<b>EASA</b>	<b>AIRWORTHINESS DIRECTIVE</b>
	<p><b>AD No.: 2014-0018R1</b></p> <p><b>Date: 20 January 2014</b></p> <p>Note: This Airworthiness Directive (AD) is issued by EASA, acting in accordance with Regulation (EC) No 216/2008 on behalf of the European Community, its Member States and of the European third countries that participate in the activities of EASA under Article 66 of that Regulation.</p>
<p>This AD is issued in accordance with EU 748/2012, Part 21.A.3B. In accordance with EC 2042/2003 Annex I, Part M.A.301, the continuing airworthiness of an aircraft shall be ensured by accomplishing any applicable ADs. Consequently, no person may operate an aircraft to which an AD applies, except in accordance with the requirements of that AD, unless otherwise specified by the Agency [EC 2042/2003 Annex I, Part M.A.303] or agreed with the Authority of the State of Registry [EC 216/2008, Article 14(4) exemption].</p>

<p><b>Design Approval Holder's Name :</b></p> <p>AIRBUS</p>	<p><b>Type/Model designation(s) :</b></p> <p>A300, A300-600, A300-600ST and A310 aeroplanes</p>
<p>TCDS Numbers : France No. 145 and EASA.A.014</p>	
<p>Foreign AD : None</p>	
<p>Revision: This AD revises EASA AD

**Appendix 1**

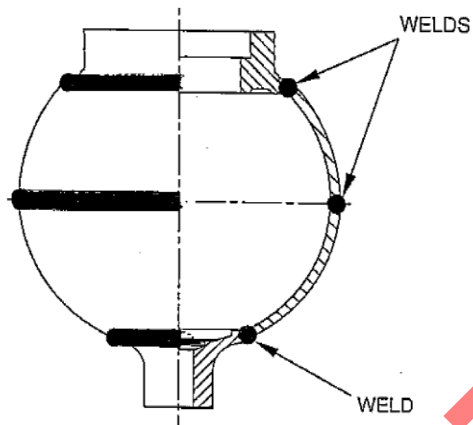
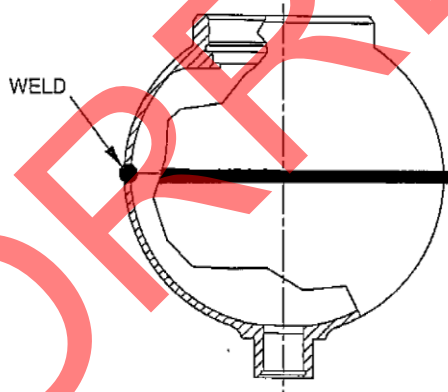
<p>(1.2) If, during the visual inspection as required by paragraph (1.1) of this AD, an old design hydraulic accumulator is found installed on any of the affected hydraulic circuits as indicated in Table 1 of this AD, as applicable to aeroplane model, replace each affected old design accumulator with a new design accumulator in accordance with the instructions of Airbus SB A300-29-0126 Revision 01, SB A310-29-2099, SB A300-29-6063, or SB A300-29-9012, as applicable to aeroplane model.</p> <p>(1.3) Irrespective of findings during the visual inspection as required by paragraph (1.1) of this AD, install placards at the designated locations of the affected hydraulic circuits indicated in Table 1 of this AD, as applicable to aeroplane model, in accordance with the instructions of Airbus SB A300-29-0127, SB A310-29-2100, SB A300-29-6064, or SB A300-29-9013, as applicable to aeroplane model.</p>	Affected aeroplanes	Affected hydraulic circuit(s)	A300, without Airbus Modification (Mod) 02447 embodied in production	Blue and Green	A300, with Airbus Mod 02447 embodied in production	Blue	A300-600 and A300F4-608ST	A310	Green
Affected aeroplanes	Affected hydraulic circuit(s)									
A300, without Airbus Modification (Mod) 02447 embodied in production	Blue and Green									
A300, with Airbus Mod 02447 embodied in production	Blue									
A300-600 and A300F4-608ST										
A310	Green

<p><b>New requirements of this AD:</b></p> <p>(2) Within 30 months or 6 000 FH, whichever occurs first after the effective date of this AD, replace the placards at the designated locations of the affected hydraulic circuits, as indicated in Table 1 of this AD, as applicable to aeroplane model, in accordance with the instructions of Airbus SB A300-29-0127 Revision 01, SB A310-29-2100 Revision 01, SB A300-29-6064 Revision 01, or SB A300-29-9013 Revision 01, as applicable to aeroplane model, on any aeroplane which has already been modified in accordance with the original issue of these same SB.</p> <p>(3) From the effective date of this AD, do not install an old design accumulator on any aeroplane.</p>
Ref. Publications:	<p>Airbus SB A300-29-0126 Revision 01 dated 12 October 2010.</p> <p>Airbus SB A300-29-0127 Revision 01 dated 08 July 2013.</p> <p>Airbus SB A310-29-2099 original issue dated 12 August 2010.</p> <p>Airbus SB A310-29-2100 Revision 01 dated 03 July 2013.</p> <p>Airbus SB A300-29-6063 original issue dated 12 August 2010.</p> <p>Airbus SB A300-29-6064 Revision 01 dated 08 July 2013.</p> <p>Airbus SB A300-29-9012 original issue dated 12 August 2010.</p> <p>Airbus SB A300-29-9013 Revision 01 dated 08 July 2013.</p> <p>The use of later approved revisions of these documents is acceptable for compliance with the requirements of this AD.</p>
